## SITE VISIT REPORT

Report No. 1

**Re: Rehabilitation of 100 ft. Sand Dome  
Fenelon (aka Cameron) Works Yard  
The City of Kawartha Lakes**

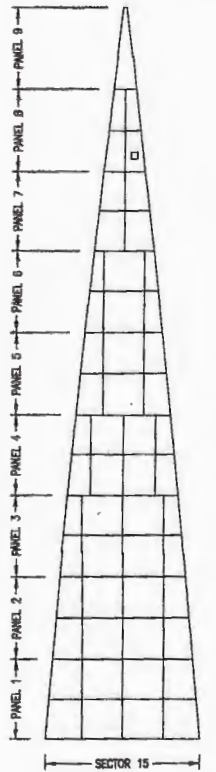
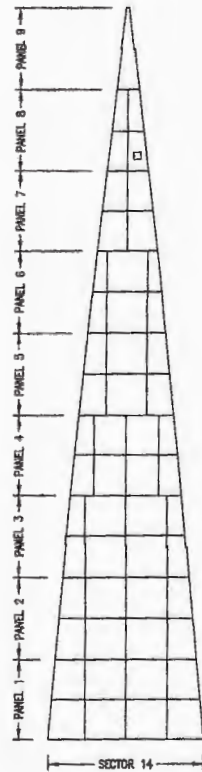
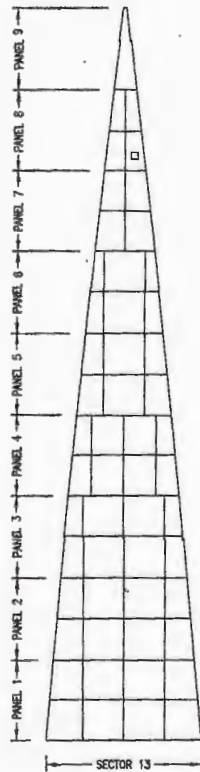
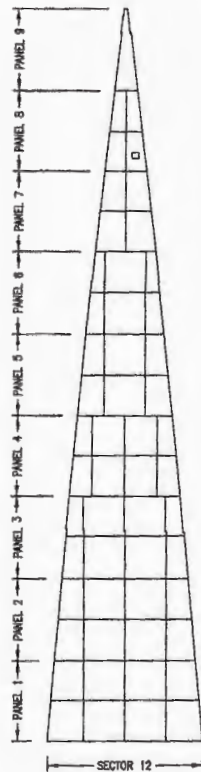
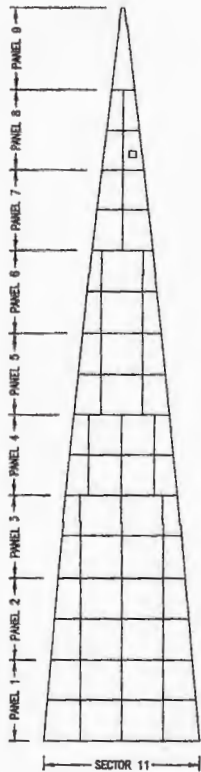
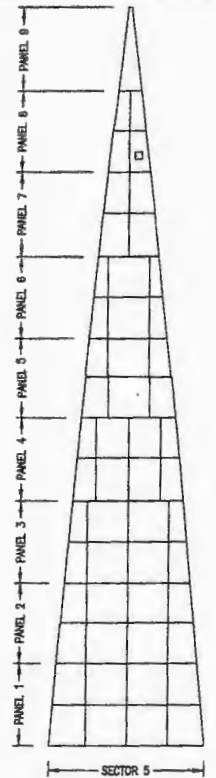
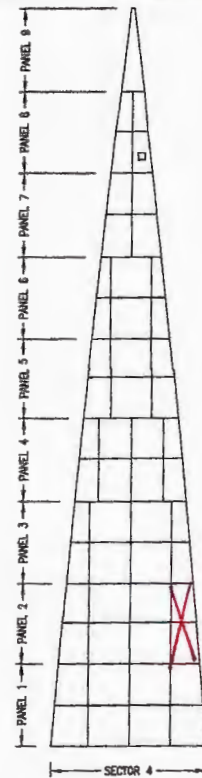
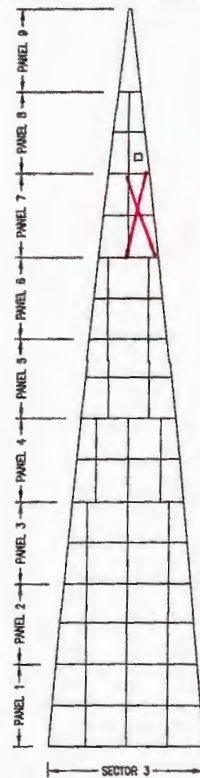
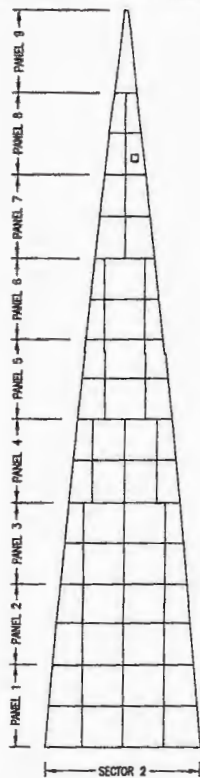
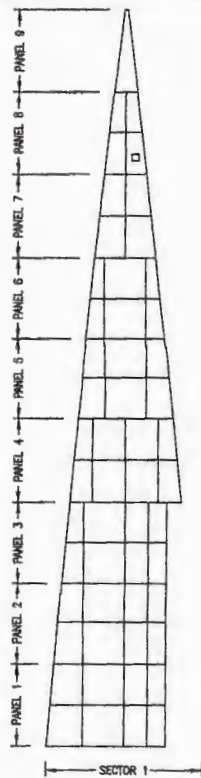
1.6 Attached is Drawing No. 17-883-4 copied as two halves and marked up in colour. Changes in the scope of work are shown in red thereon. All such additional work is to be done on the Contract's Unit Price basis.

1.7 Further to No. 1.6 the changes to the plywood repairs to be undertaken per the Unit Price provisions of the Contract are as follows.

| Sector 3 Panel No. 7.....  | 1 sheet  |
| Sector 4 Panel No. 2.....  | 1        |
| Sector 20 Panel No. 4..... | <u>1</u> |

1.8 Further to No. 1.6, the changes to the lumber repairs to be undertaken per the Unit Price provisions of the Contract are as follows.

| Sector 7 Panel No. 1..... | 14 bd ft  |
| Sector 7 Panel No. 2..... | <u>14</u> |

51-1  
17-883  
18/5/18

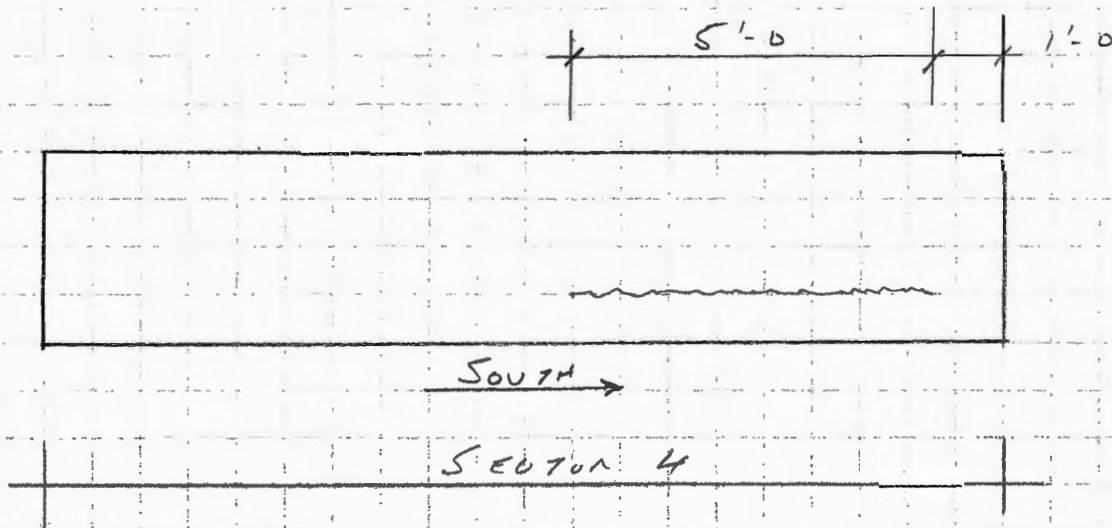
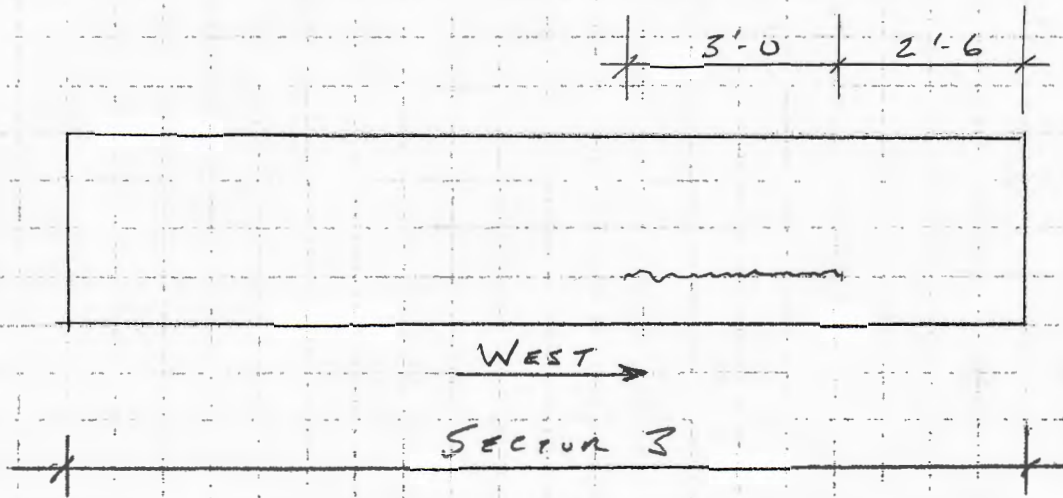
2.4 Additional epoxy repairs of some parts of some sectors are to be undertaken on the Unit Price basis of the Contract and per the procedure of No. 2.5 following. The locations and extent of such repairs are shown by the irregular lines drawn on sketches attached hereto as pages S1-1 to S1-5 inclusive. The aggregate cold-joint/crack length shown is 45 ft. to be repaired at a Unit Price of \$200.00 per foot, i.e., \$9,000.00. The total cold-joint/crack length and cost are to be confirmed by re-measurement once the work is complete.

- a) City to dismantle bull-ring boards.
- b) City to remove sand/salt and other debris remaining behind bull-ring.
- c) City to pressure-wash inside face of concrete foundation.
- d) Contractor to undertake repairs as/where described herein.
- e) The scope of the repairs of (d) is to be increased or decreased as appropriate to the found conditions and only with the prior approval of the City. A record of any such changes is to be made and distributed.
- f) City to caulk all areas of the crack/cold joint that were not subject to epoxy repair.
- g) City to reassemble bull-ring.
